XD Upgrade ***HPR130 and HPR260***

Field Service Bulletin

806480 – Revision 1 – March, 2010

Jumpers

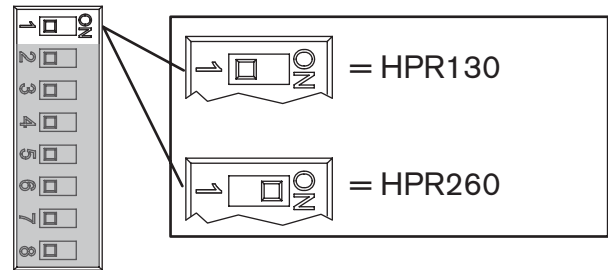
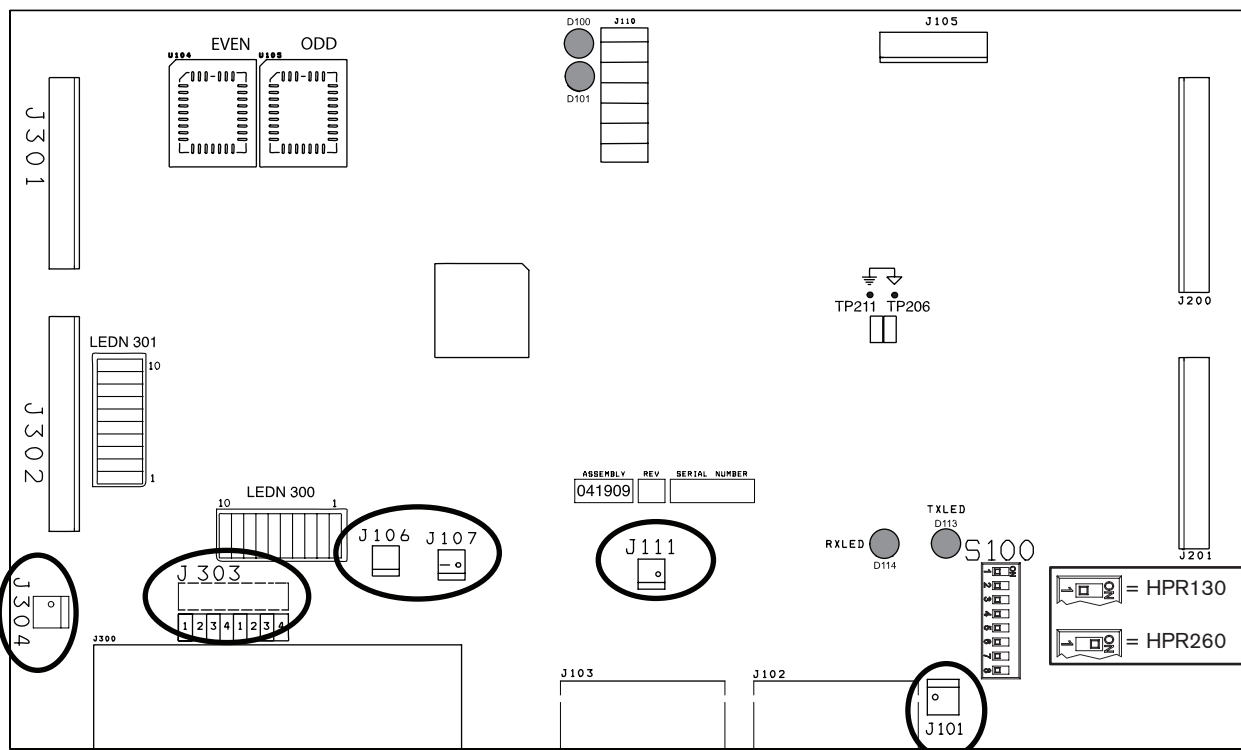
Jumpers on the new control board (041993) must match the jumpers present on the old control board (041909). Configure the jumpers on the new control board to match the jumpers on the old control board in the corresponding locations. See the figure on the next page for jumper locations.

DIP switch location and settings

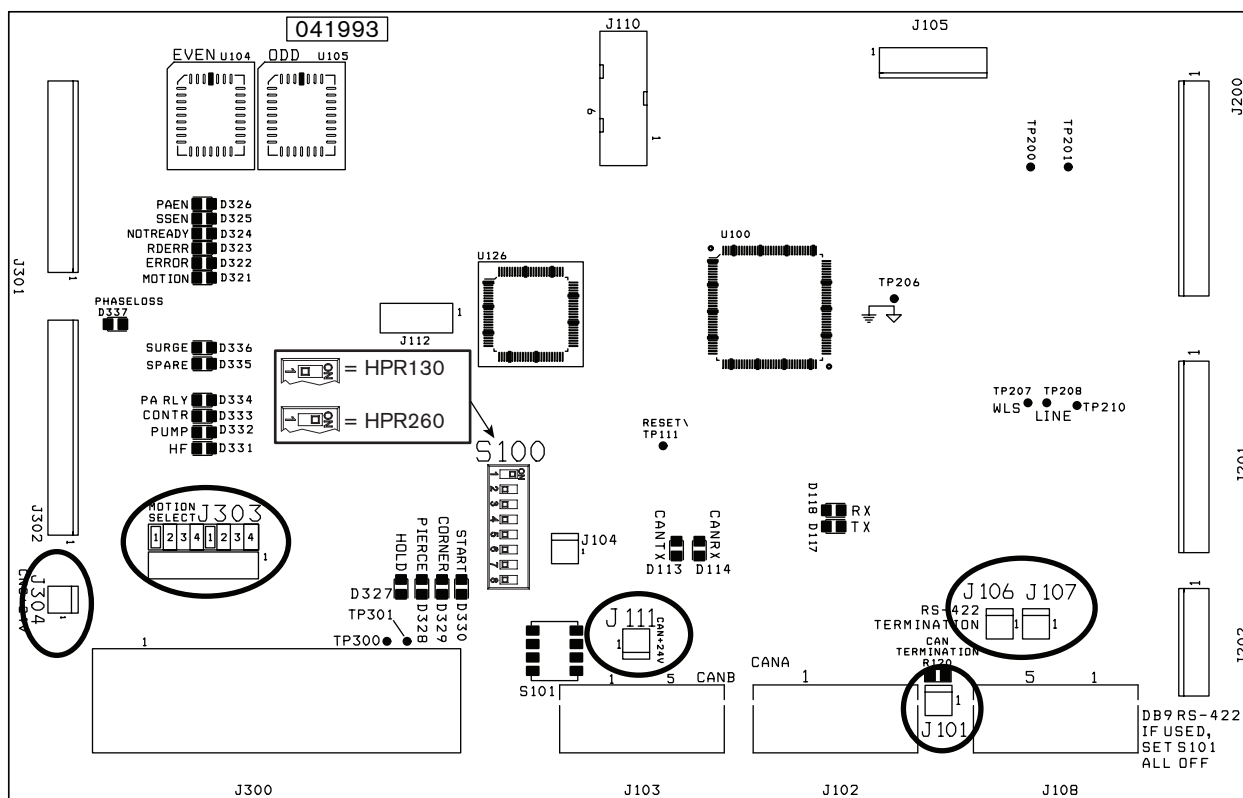
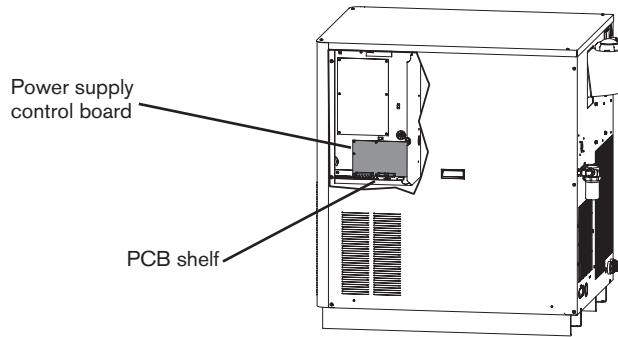
The dip switches on the new board must match the dip switches on the old board.

Switch number 1 determines if the board is being used in an HPR130 (OFF position) or an HPR260 (ON position).

Switches 2 and 3 are used when the plasma system has more than one power supply in series (also referred to as multi-drop systems). Switches 4 through 8 must be in the OFF position. See the wiring diagrams in your instruction manual for more information on multi-drop systems).

HPR130 and HPR260 control board location

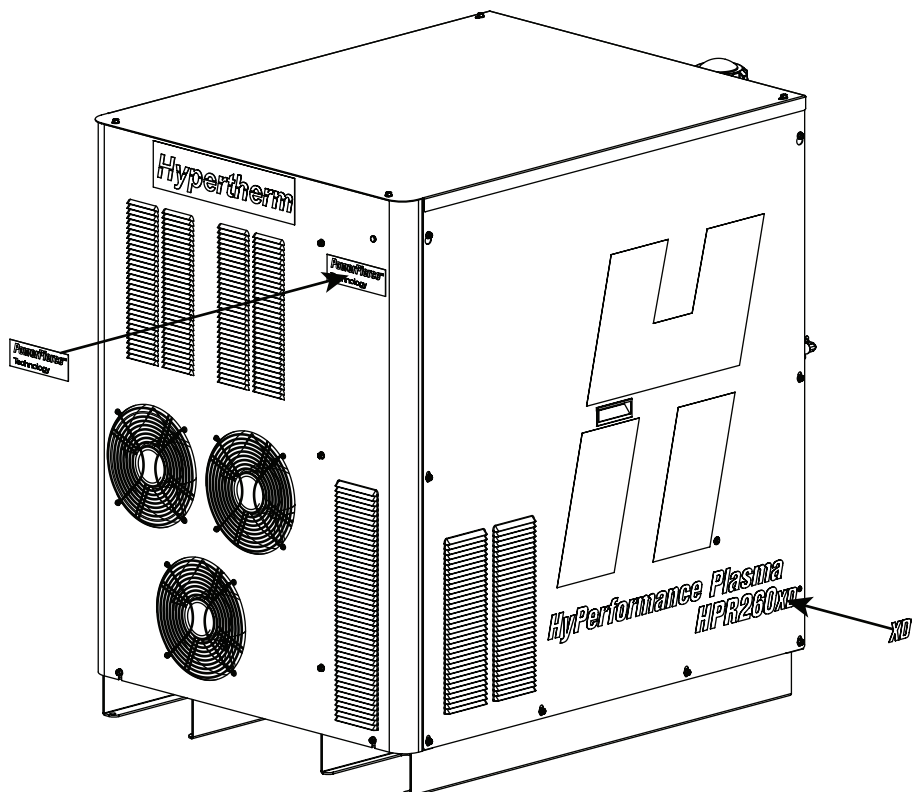
1. Turn OFF all power to the system.
2. Remove the right side cover from the power supply to access the control PCB. See figure above. The location of the control board is the same for the HPR130 and HPR260.

3. Remove all the connectors from the control board. Also remove the 4-40 standoffs on the dsub connectors that attach the control board to the PCB shelf. Save the standoffs for use when installing the new control board.

4. Remove the old control board (041909) from the power supply.
5. Install the new, properly configured, control board (041993) in the power supply, reinstall the 4-40 standoffs, and plug in all the connectors.

Install the chopper wire group (HPR260 only)

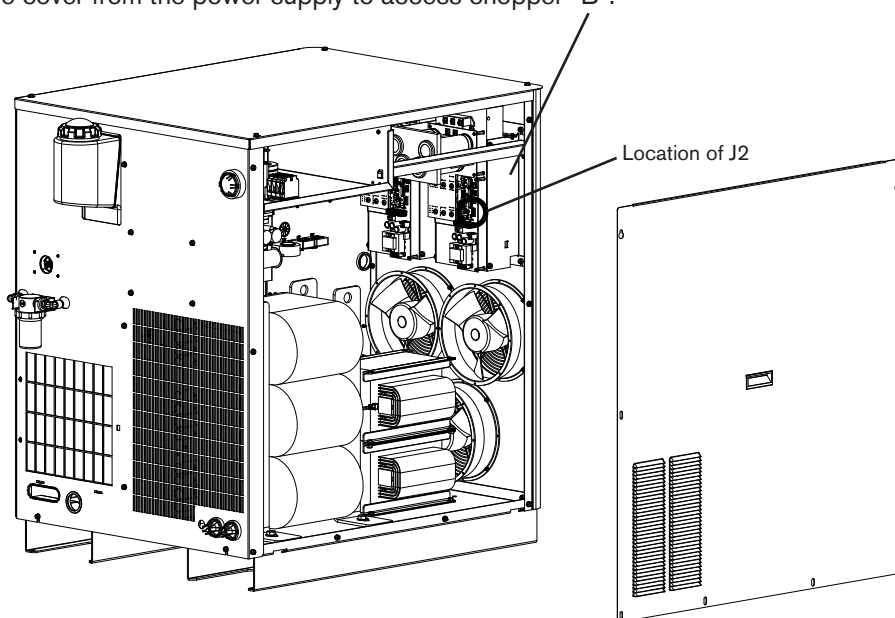
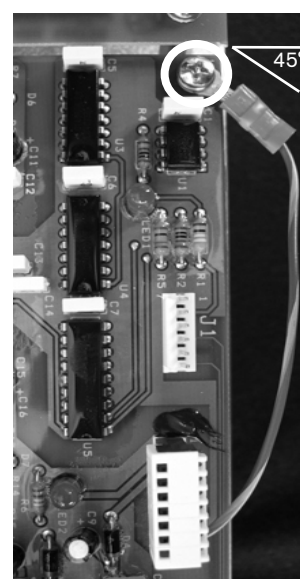
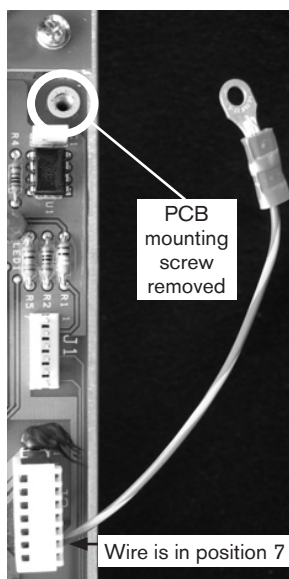
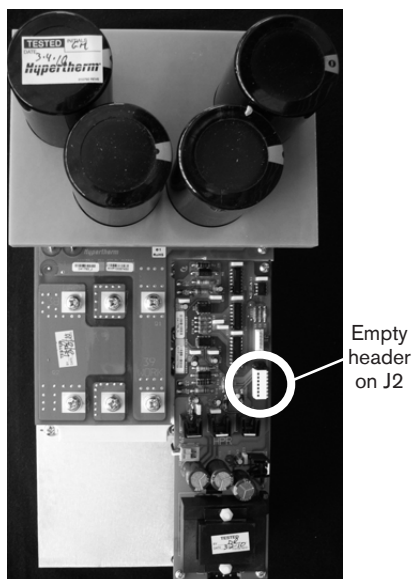
Caution: Failure to install this wire group in an HPR260 power supply can result in damaged to the chopper.

3. Remove the empty header (plug with no wires) from receptacle J2 on the chopper.
4. Install the new wire group (229386) on J2 and remove the PCB mounting screw.
5. Secure the ring terminal to the PCB at a 45 degree angle, using the screw removed in step 4.

Install the off-valve adaptors (manual gas systems only)

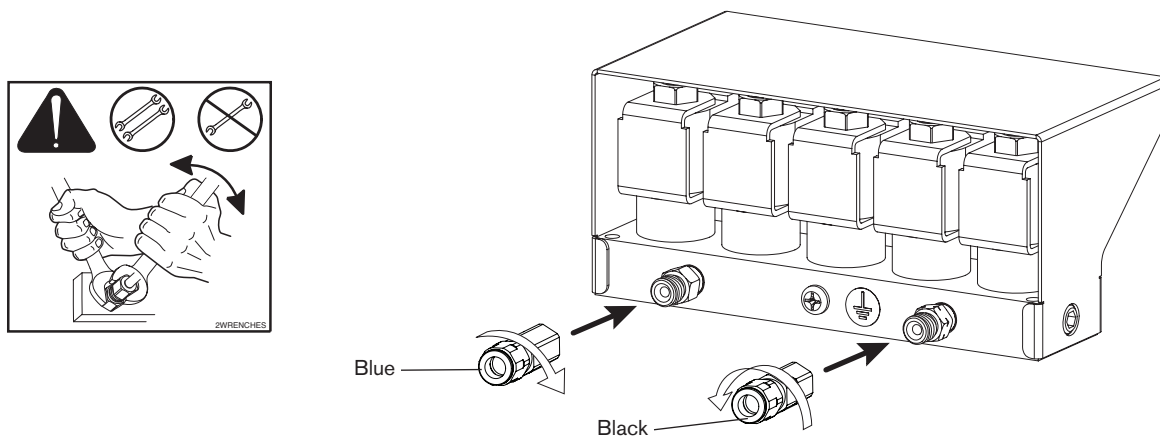
1. Turn OFF all power to the system.
2. Remove the cover from the off-valve.
3. Use 2 wrenches to install the adaptors as shown below. 1 has right hand threads and the other has left hand threads.
4. The new torch leads can now be used with the off-valve.

Install the metering console adapters

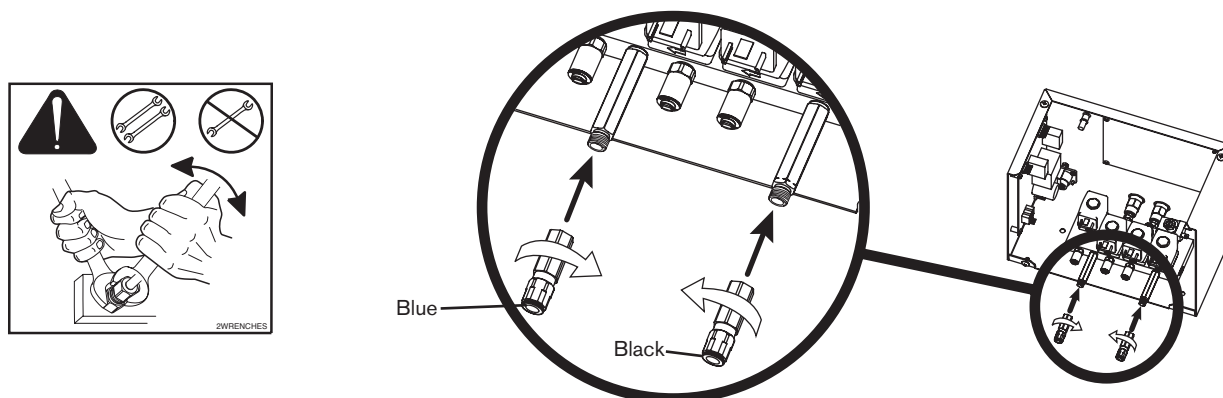
1. Turn OFF all power to the system.
2. Remove the cover from the metering console.
3. Use 2 wrenches to install the adapters as shown below. 1 has right hand threads and the other has left hand threads.
4. The new torch leads can now be used with the metering console.

Update the firmware

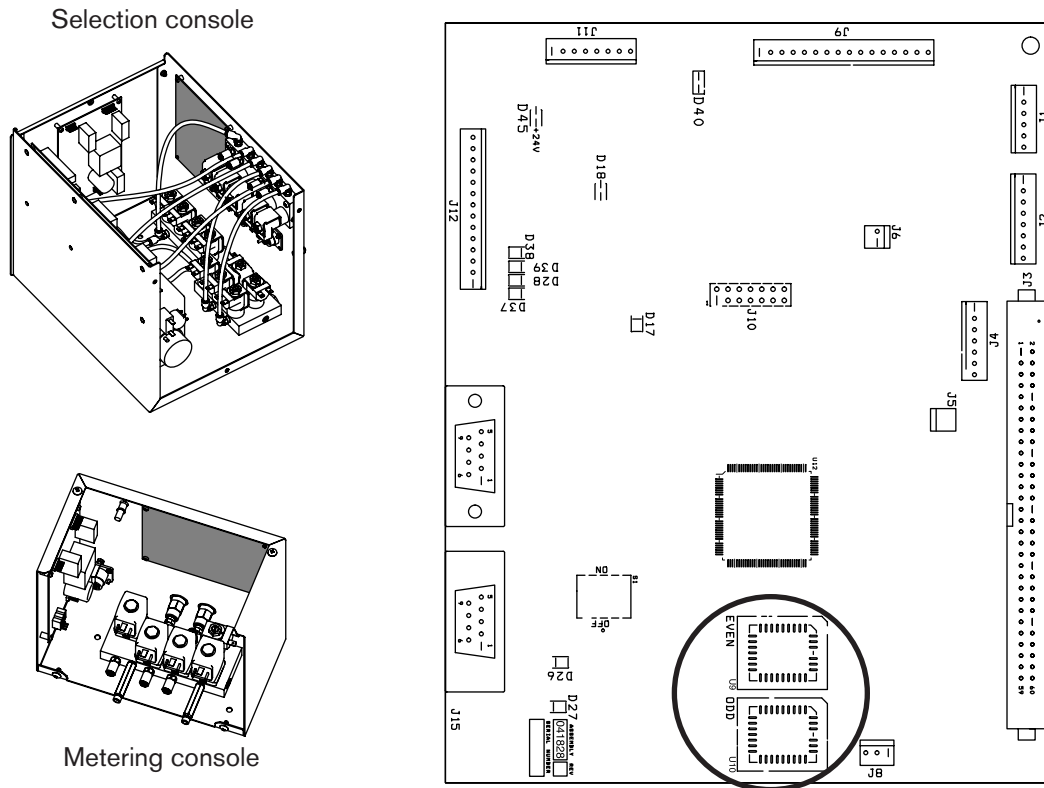
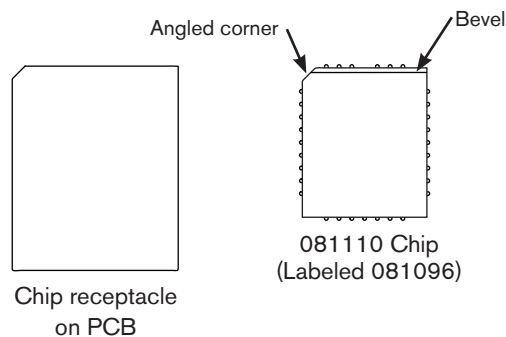
1. Turn OFF all power to the system.
2. Remove the covers from the selection console and the metering console to access the control PCB (see figure above).
3. Remove the even (U9) and odd (U10) chips from the boards using the extraction tool (027338) provided in this kit.
4. Install the new chips 081110 (labeled 081096) onto the control board.

NOTE: Make sure the chips are oriented correctly before installation. There is a bevel on the top edge of each chip and the upper left corner is angled (see figure below).
